**The ASPIS-PCA Slab
Geometry Benchmarks.**

Blind Test Edition.

AEW - M 2329

CORRIGENDA TO AEEW - M 2329

Figure 6.1 MCBEND model of the NESDIP 1 array

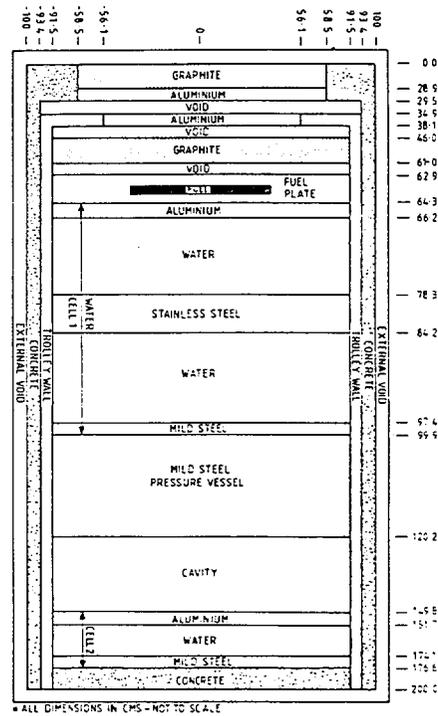
Figure 6.1 Distances from inside face of trolley front should change to
... 66.2, 78.3, 84.6, 97.8, 100.3, 120.6, 150.2, 152.1, 174.5, 180.0, 200.0

Figure 6.2 MCBEND model of the NESDIP 2 array

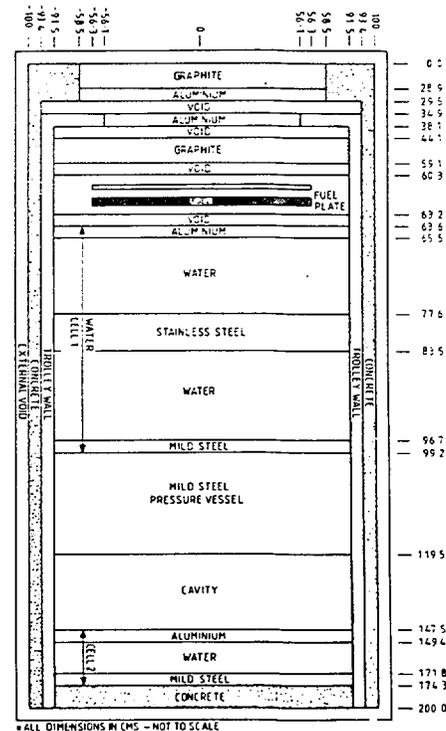
Figure 6.2 Distances from inside face of trolley front should change to
... 65.5, 77.6, 83.9, 97.1, 99.6, 119.9, 147.9, 149.8, 172.2, 174.7, 200.0
